### Seismic Walkdown Checklist (SWC)

Peach Bottom Atomic Power Station Unit 3  
MPR-3812, Revision 3  
Correspondence No. RS-12-173

Equipment ID No. LT3-2-3-61 Equip. Class<sup>12</sup> (18) Instruments on Racks / Not on Racks

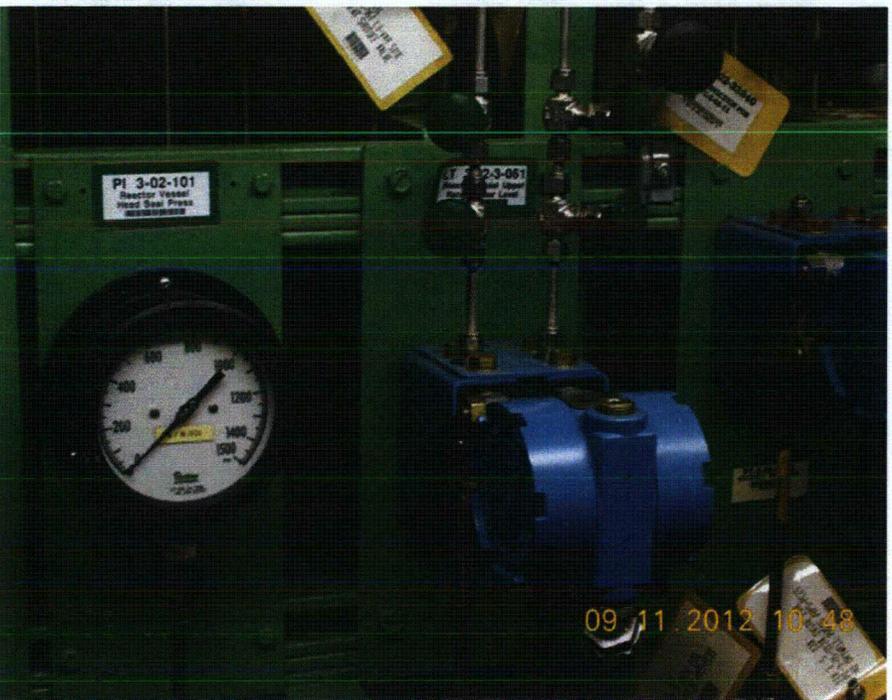
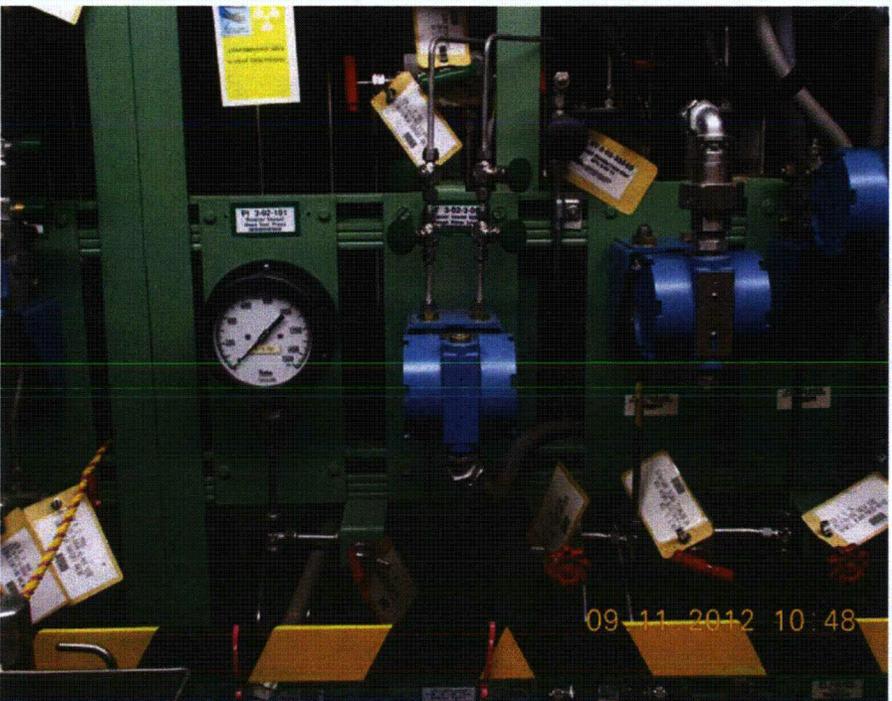
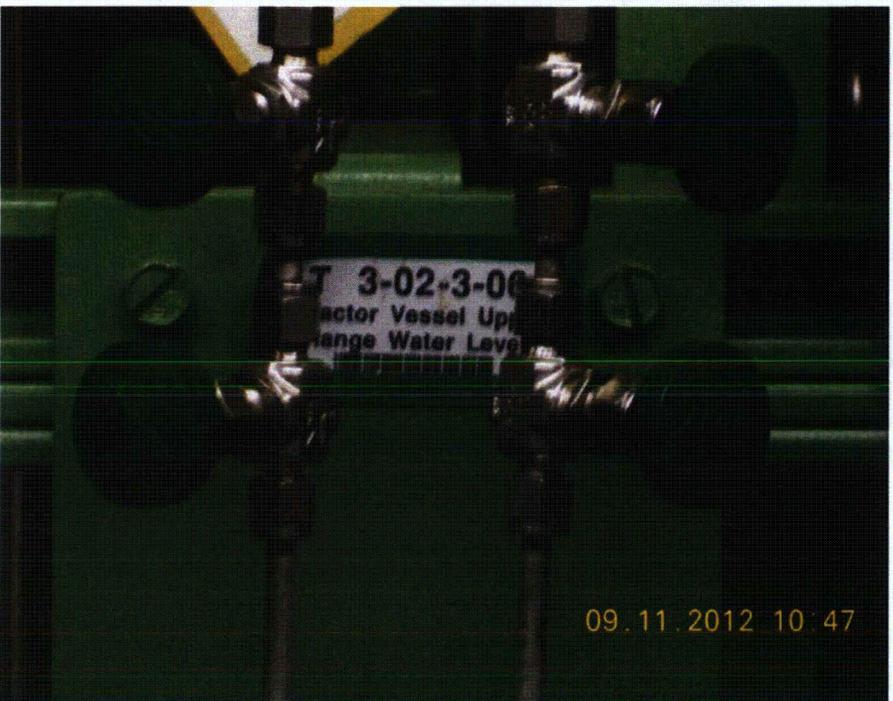
*Temporary barriers blocked by protective fence*

Equipment ID: LT-9123A

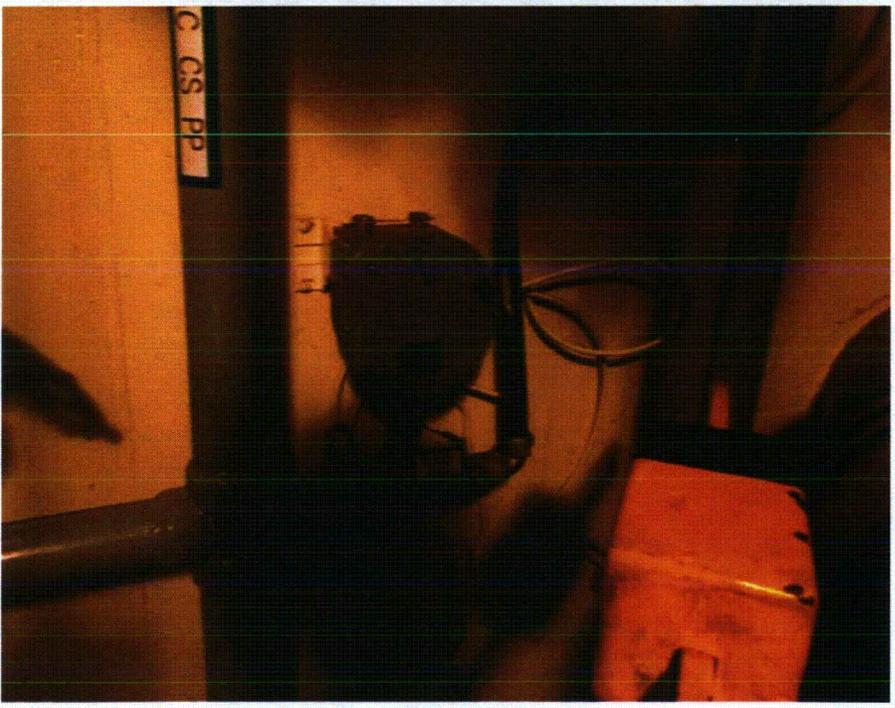
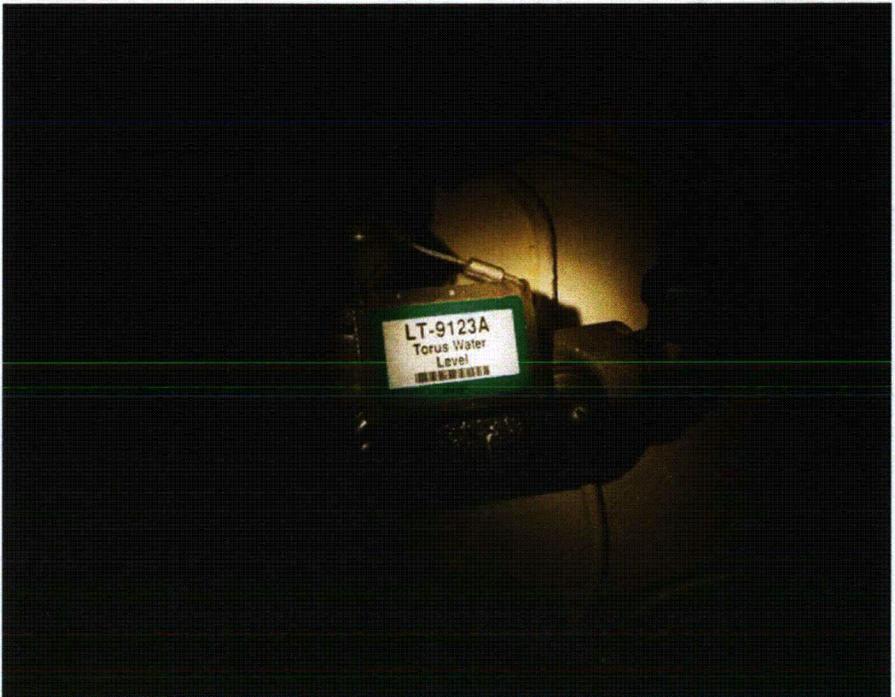
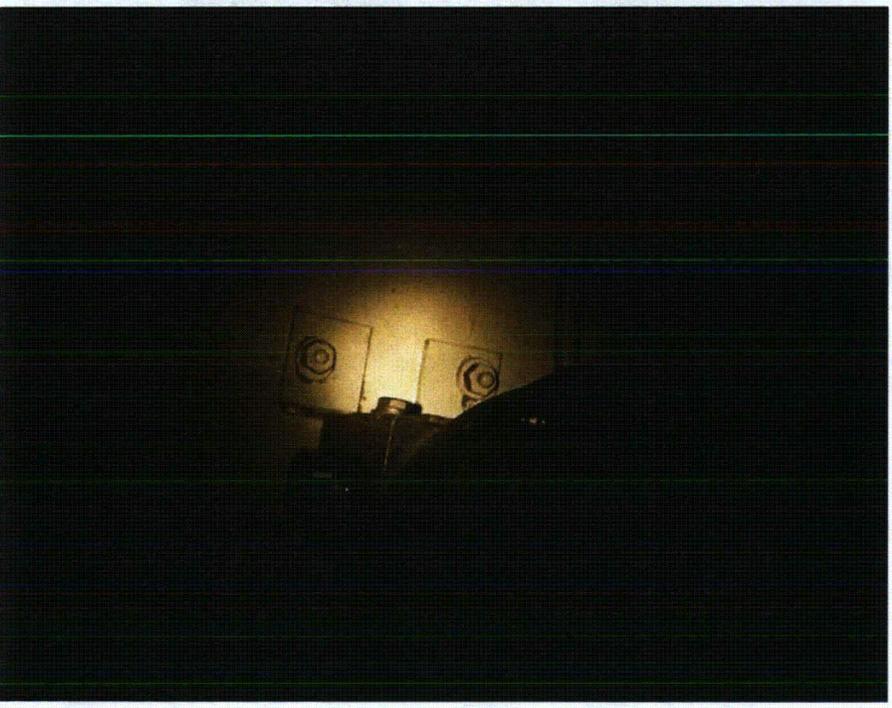
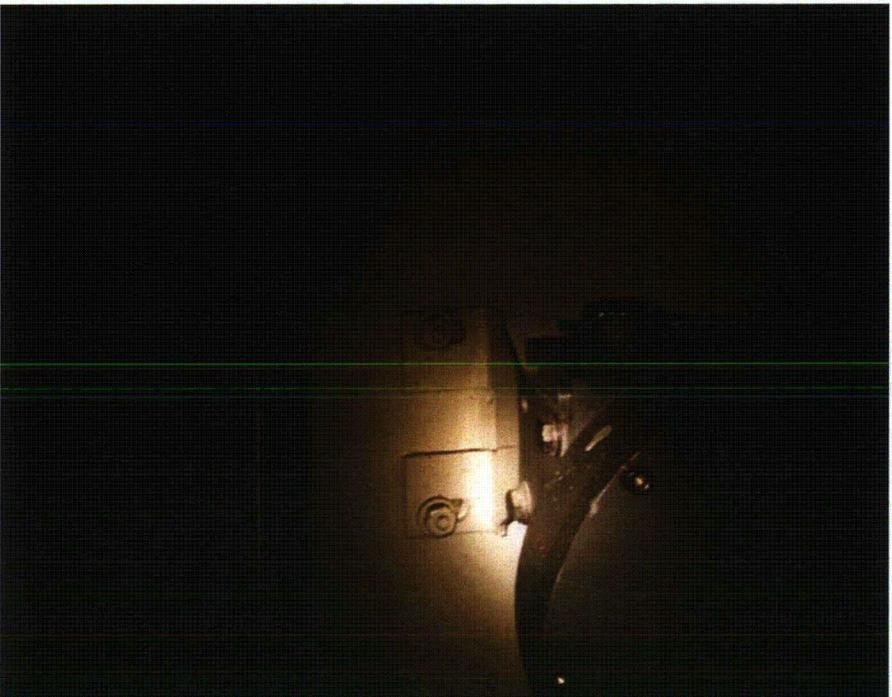
*No soft targets*

Equipment ID: MO-3-10-013C

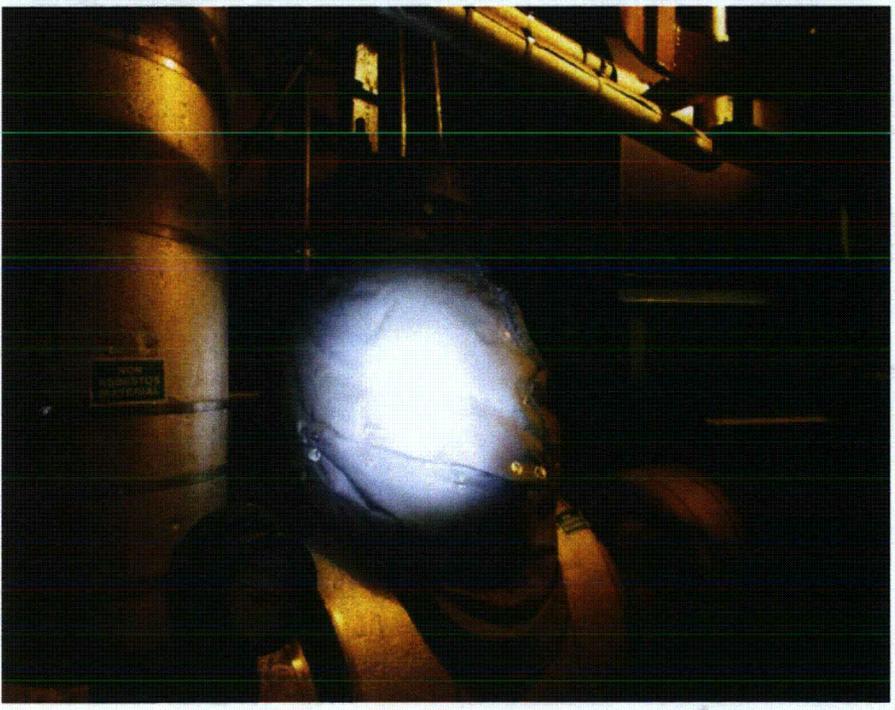
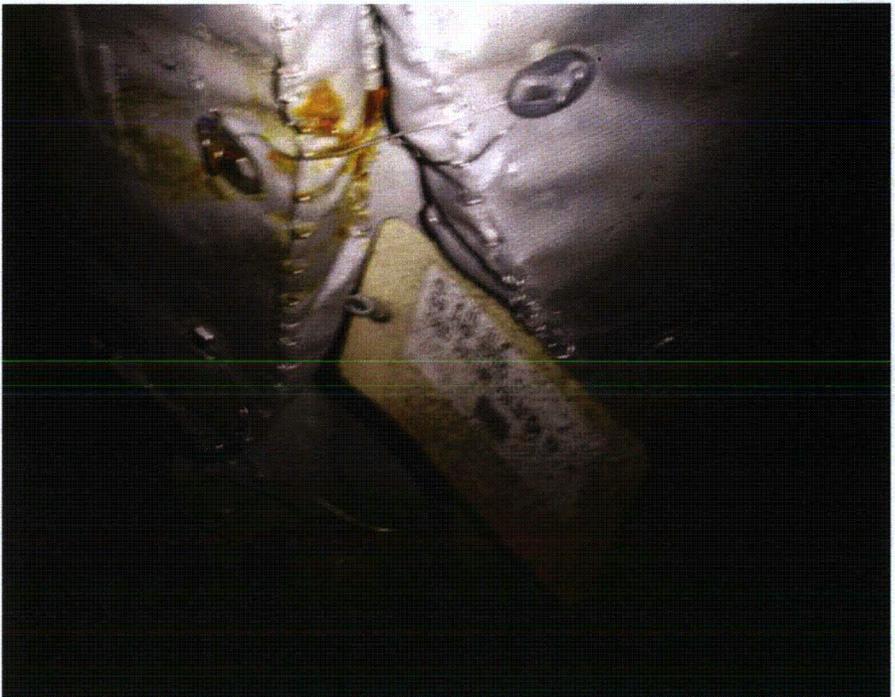
*No credible II/I threat. Overhead gratings secured.*

Equipment ID No. M03-10-015A <sup>c CBS</sup> Equip. Class<sup>12</sup> (08a) Motor Operated Valves

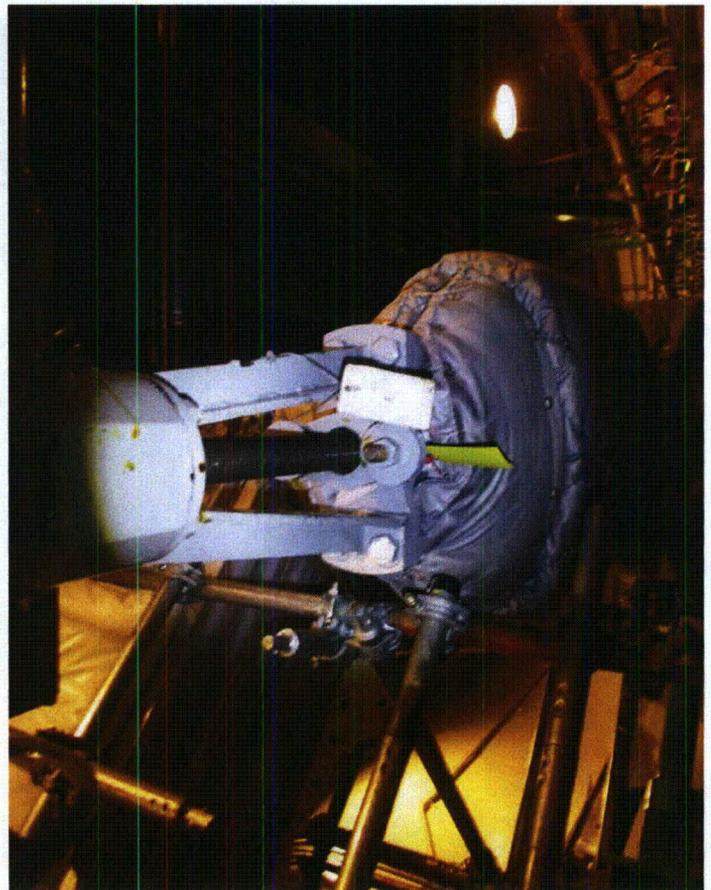
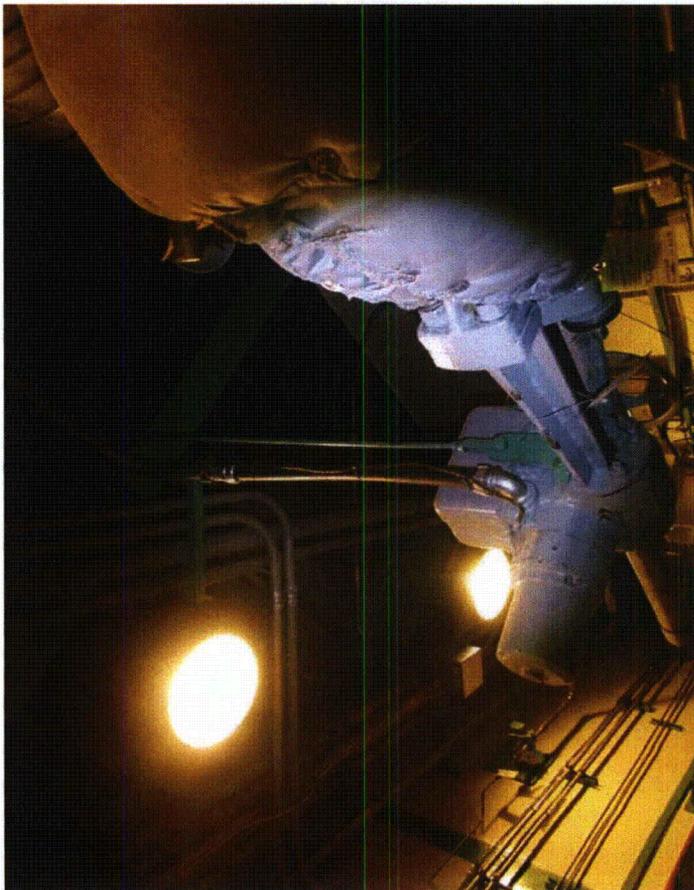
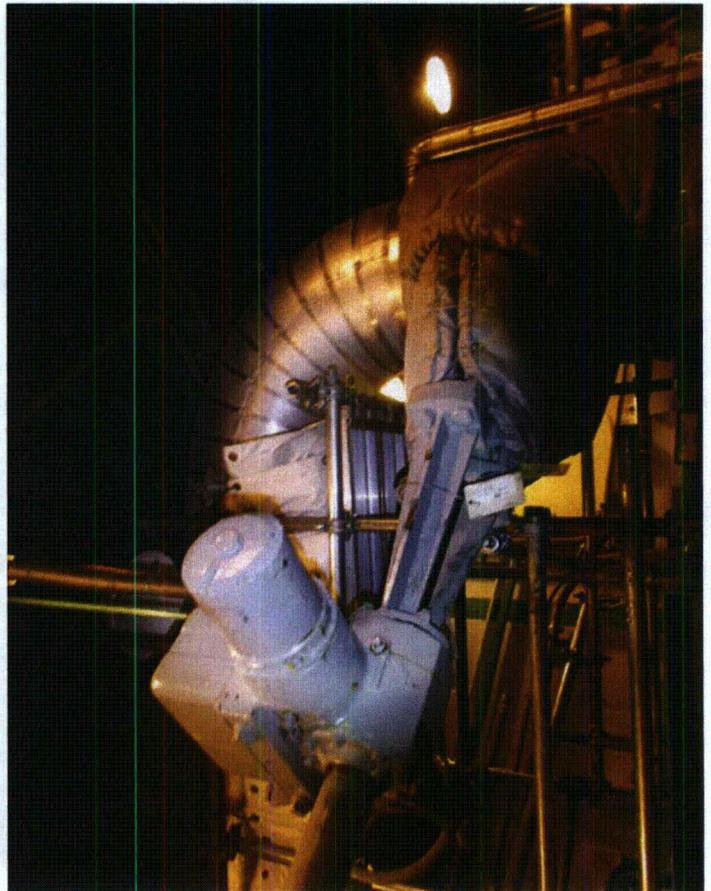
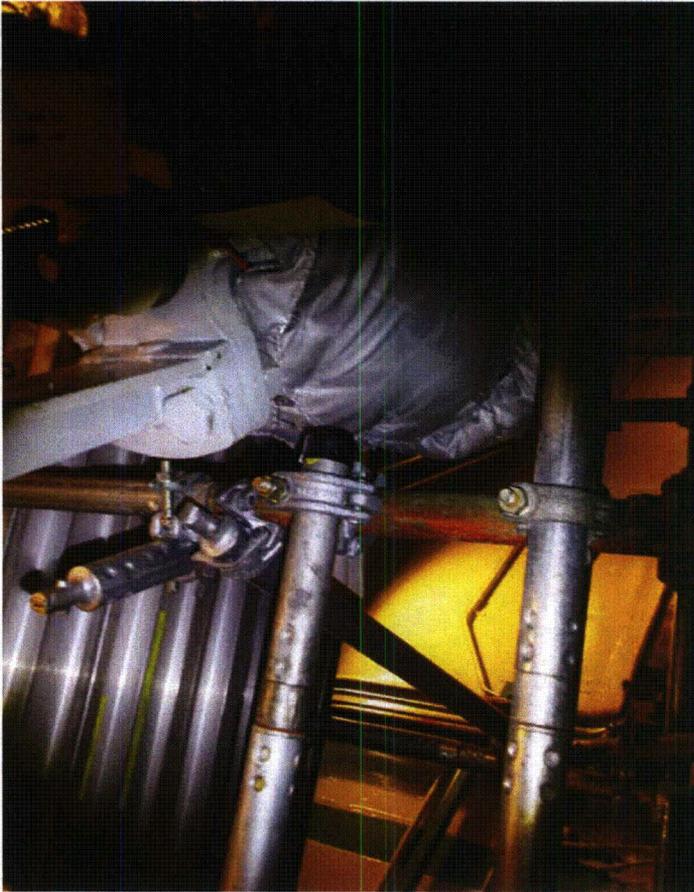
*No soft targets identified.*

*No II/I issues identified.*

*Nearby scaffolding is secured adequately*

Equipment ID No. M03-10-89A<sup>C</sup> Equip. Class<sup>12</sup> (08a) Motor Operated Valves

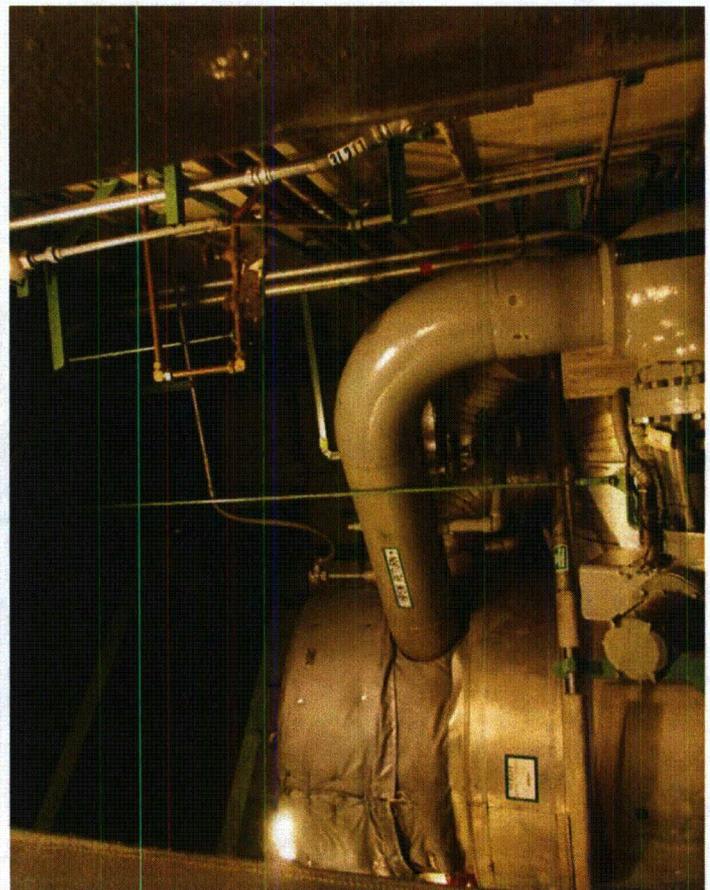
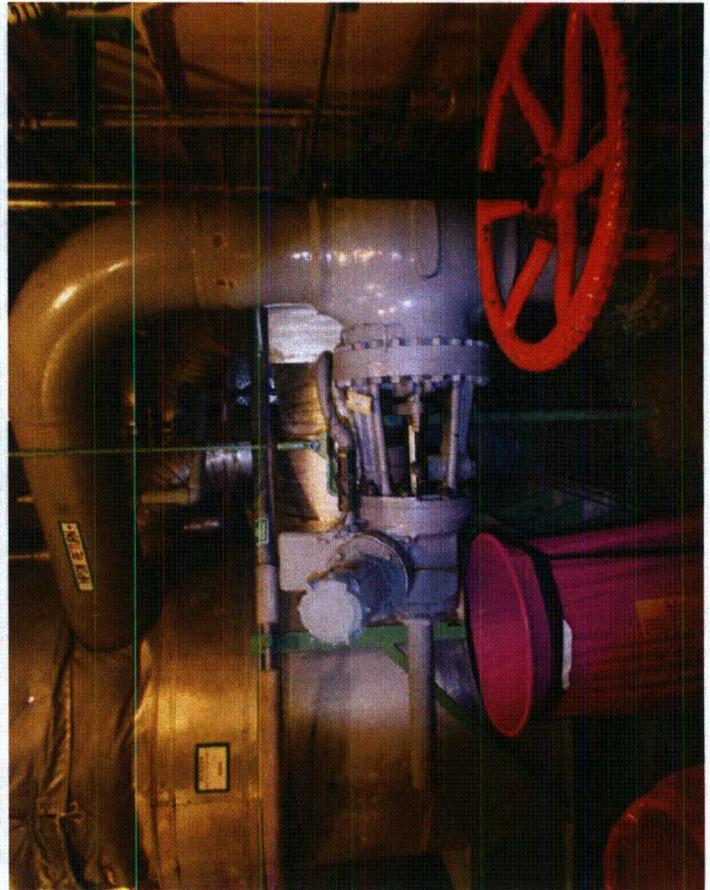
*No credible I/F issues identified*

Equipment ID No. MD3-30-3233A Equip. Class<sup>12</sup> 8A - Motor Operated  
 Equipment Description UNIT 3A SLUICE GATE  
 Location: Bldg. Screenhouse Floor El. 116 Room, Area S/H-4  
 Manufacturer, Model, Etc. (optional but recommended) \_\_\_\_\_

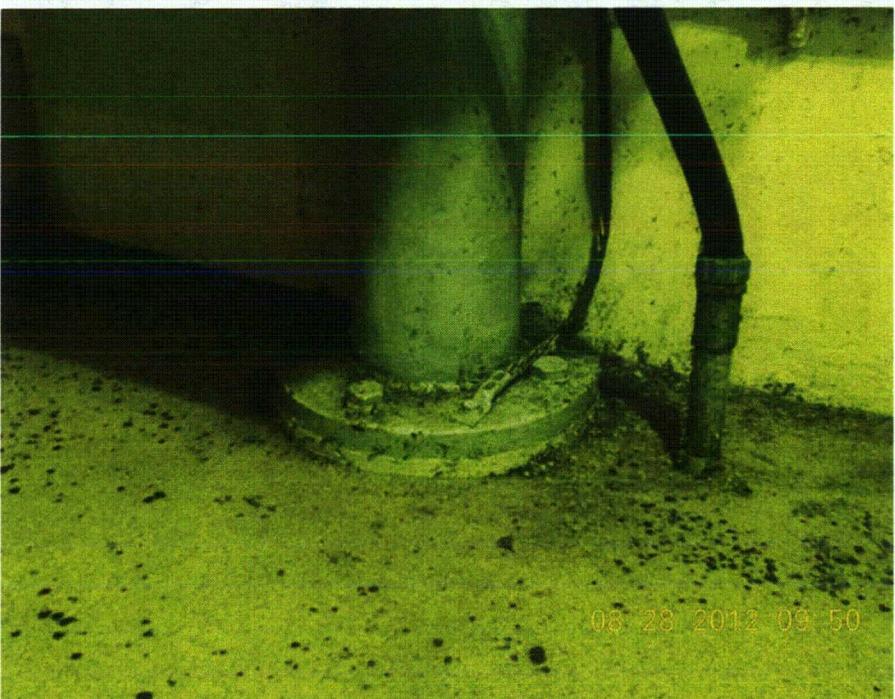
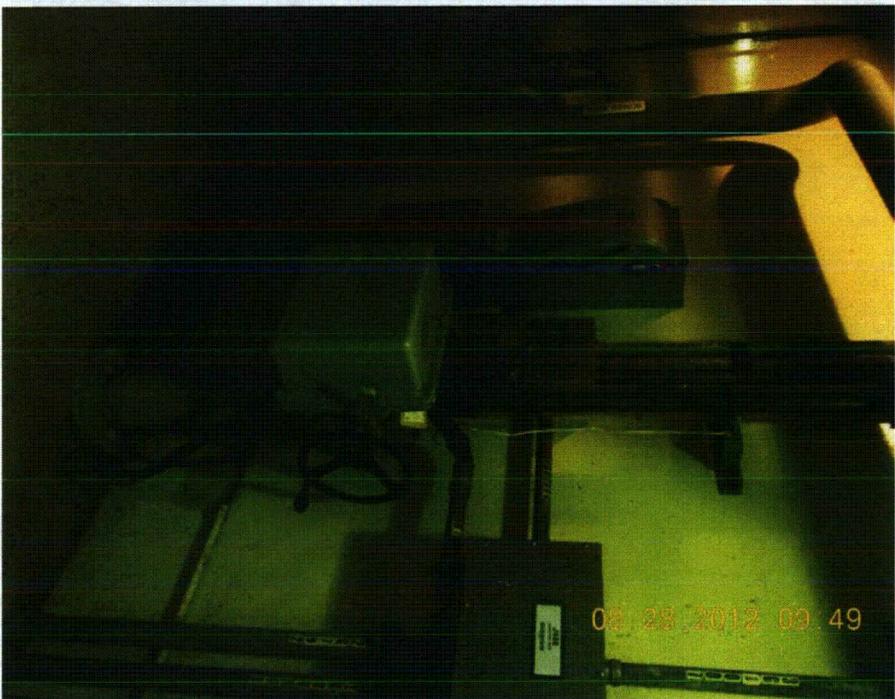
5. Is the anchorage configuration consistent with plant documentation?  Y  N  U  N/A  
 (Note: This question only applies if the item is one of the 50% for which an anchorage configuration verification is required.)  
 . Matches Dwg. # 6280-C20-10-4 (Rev. 4)

*ATA gwr 8/31/2012 #1. Evaluation only applies to motor-operator due to inaccessibility of actual sluice gate for visual inspection*
